Access Compliance Report Public Rights-of-Way (Curb Ramps)

Main Street: EARLHAM_ST Cross Street: E_EL_CARMEN_AVE Location: NE

ADA ID: RPAT211020095021 Ramp Type: Type 1 - Perpendicular Diagonal Initial Pass/Fail: Pass Overall Compliance: No Severity Score: 4

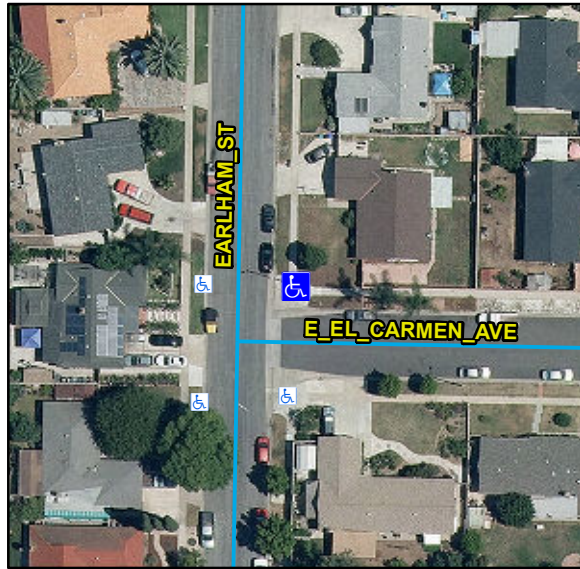
R304.2.2, R304.2.1, STD 1115

Remove & Replace Curb Ramp With Two New Directional Ramps or Equivalent.
